ATLANTIC CROSSING

Project Number: 217093

#### CLASS II MODIFICATION 2019 - 8.2.2019

PLAZA SUPPLEMENTAL EXHIBITS

# BLDG III ELEVATIONS

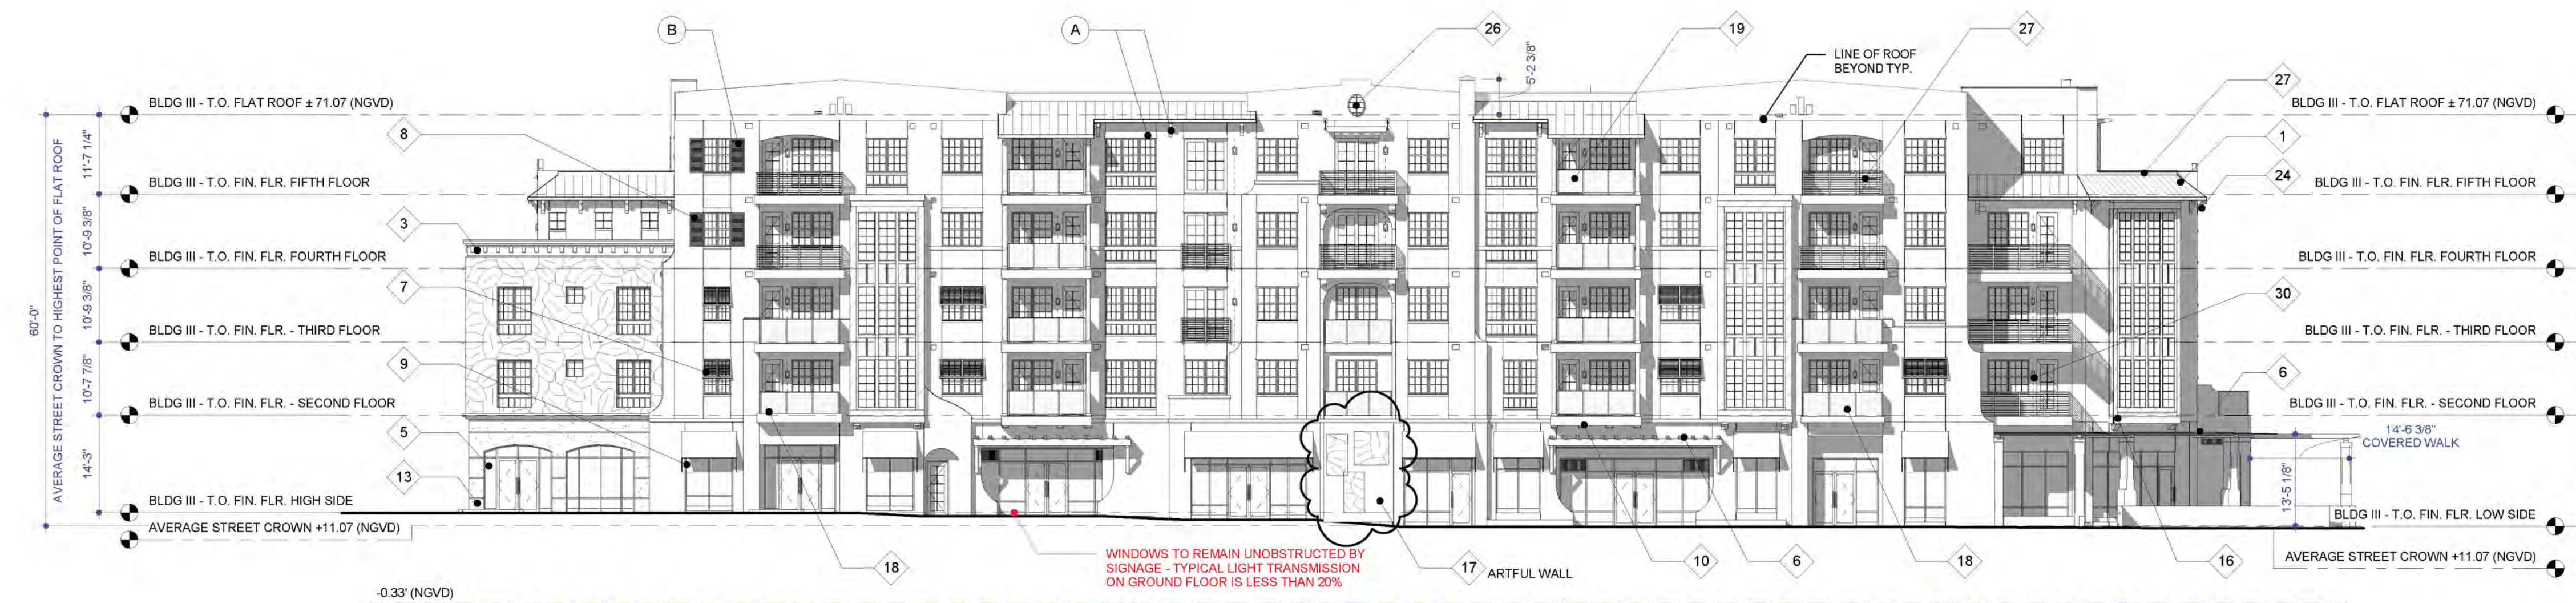
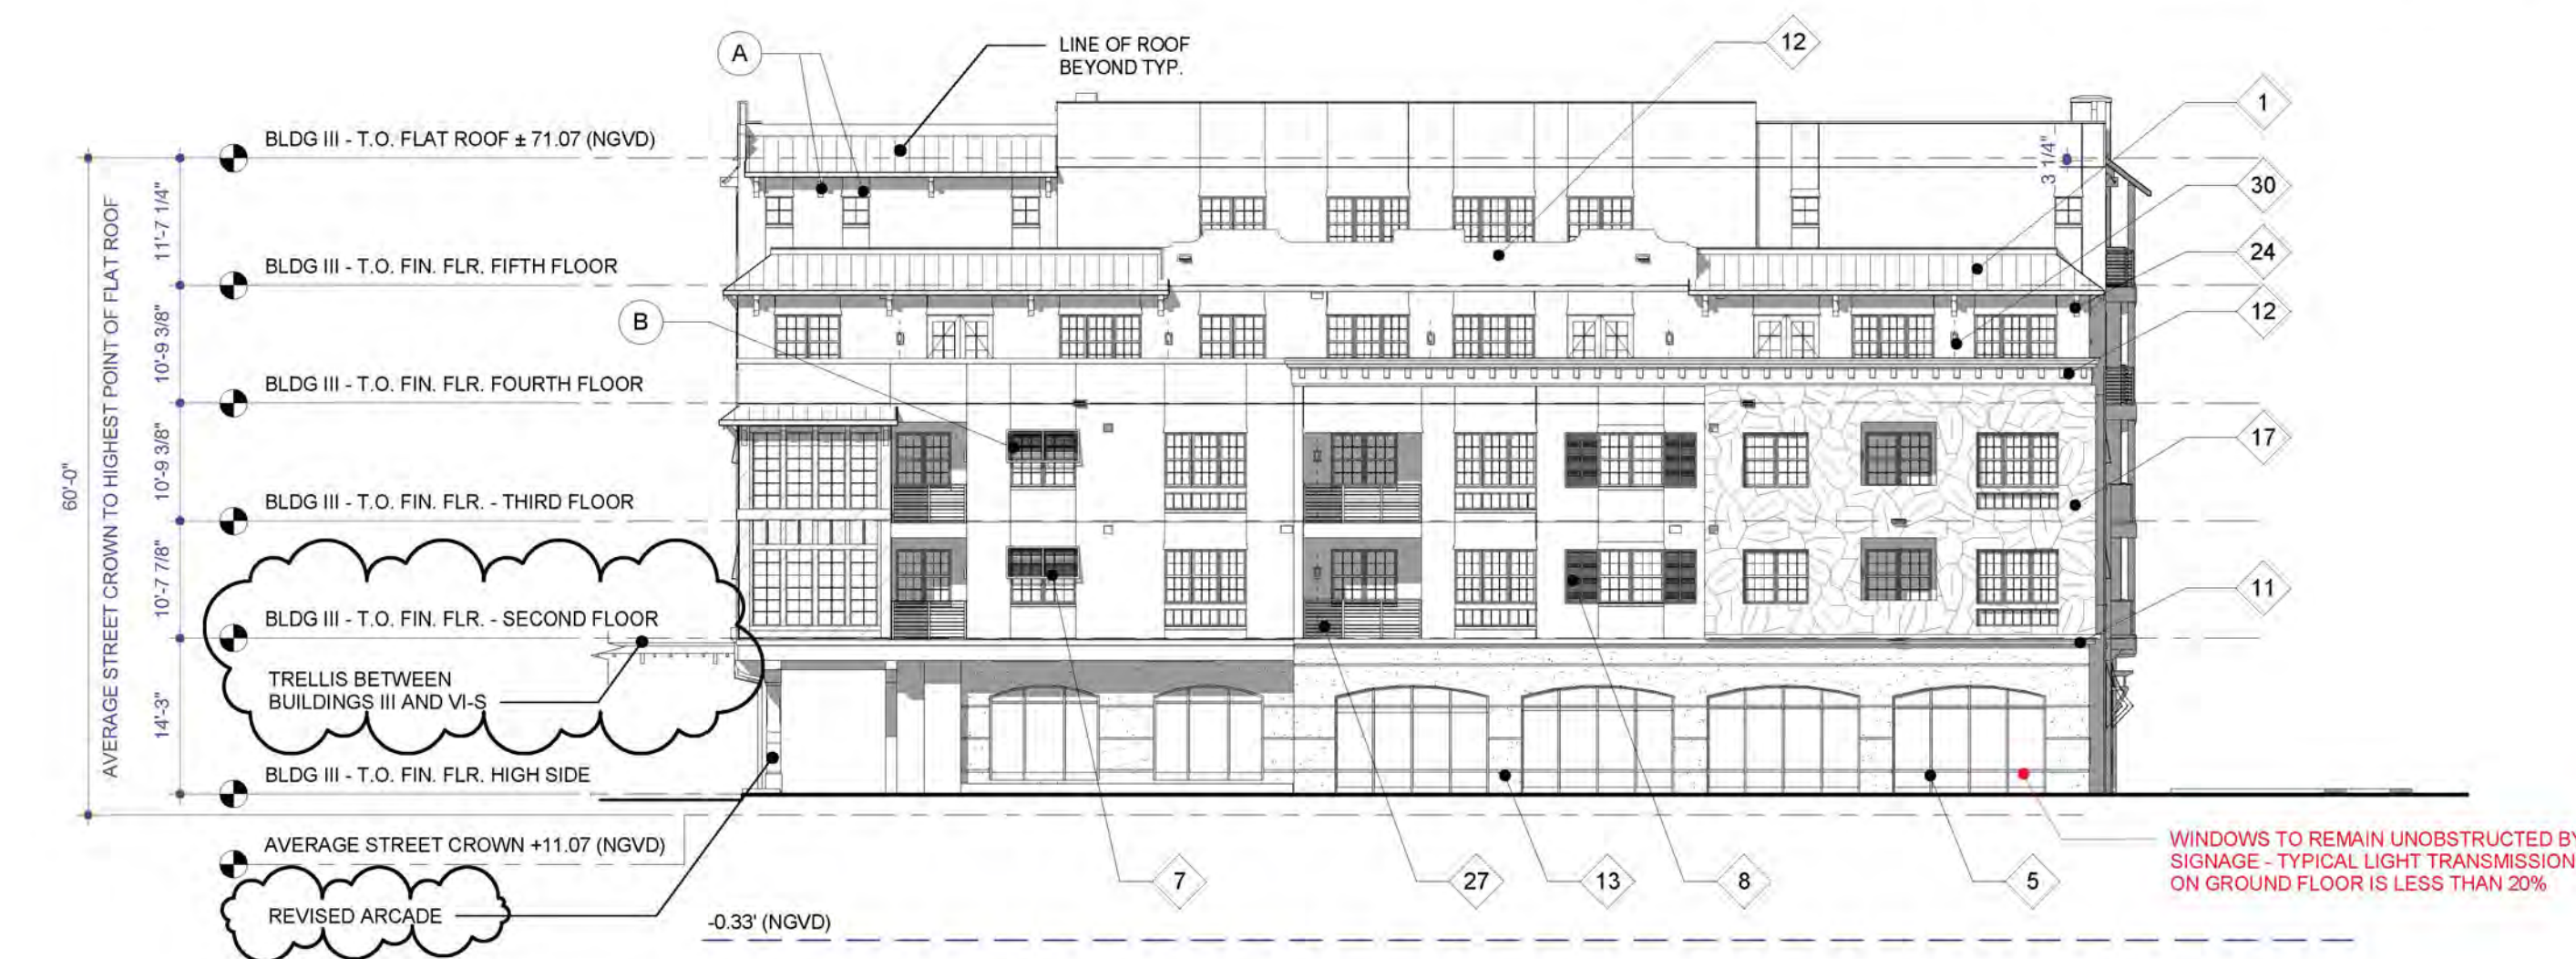
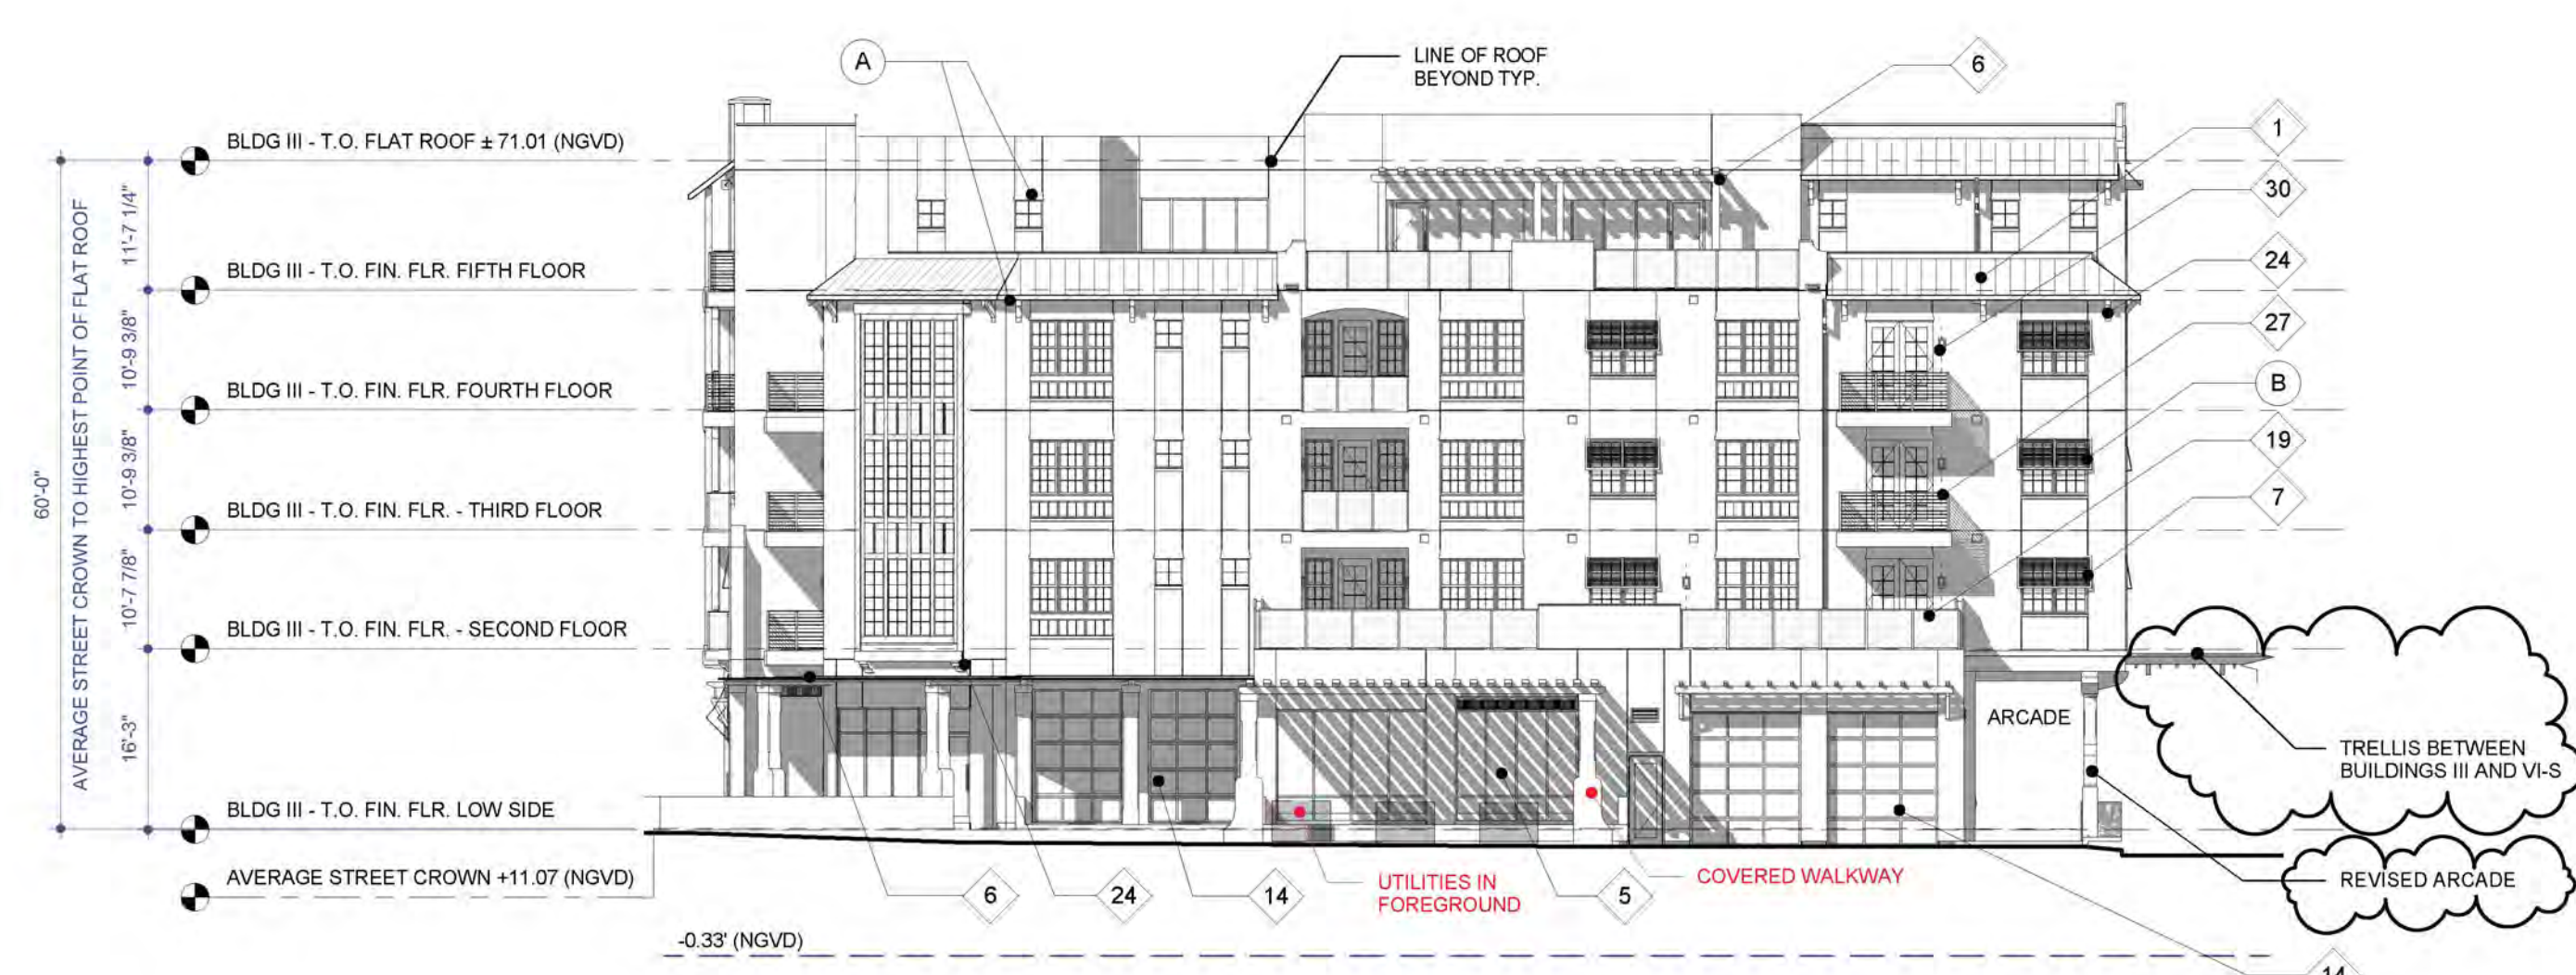
- BUILDING III NORTHWEST FOOTPRINT ADJUSTED DUE TO ADDITION OF RAMP AT NE 6TH AVENUE
- WINDOWS OF THE BUSINESSES AND OFFICES REMAIN UNOBSTRUCTED BY SIGNAGE
- LIGHT TRANSMISSION FOR GROUND FLOOR GLASS AREA TO BE NO GREATER THAN 20%
- KNOX BOXES TO BE PROVIDED AT ROLL DOWN GATES
- GREEN WALL IS CONSIDERED A TRELLIS WHICH SHALL BE ALLOWED TO ENDOACH INTO SETBACK ALONG FEDERAL HIGHWAY
- ADDED INGRESS/EGRESS RAMP AT NE 6TH AVE

- ADD ARCADE ALONG THE NORTH ELEVATION
- ADJUST POSITION OF LOADING AREA
- ADJUST EAST AND WEST ELEVATIONS DUE TO ADDITION OF ARCADE

- SCULPTED FORMS AT ARCADE AND AT FEATURE ELEMENTS OF THE BUILDING
- RE-SCALE WINDOWS AT CORNERS
- WOOD DETAILING AS ACCENT AT VERTICAL FORMS
- ENTRANCE DETAIL AT BUILDING CAP
- RE-DETAIL ARCADE AND LOW ROOF FORMS

- REVISE DETAIL AT ARCADE
- ADD TRELLIS BETWEEN III & VI-S
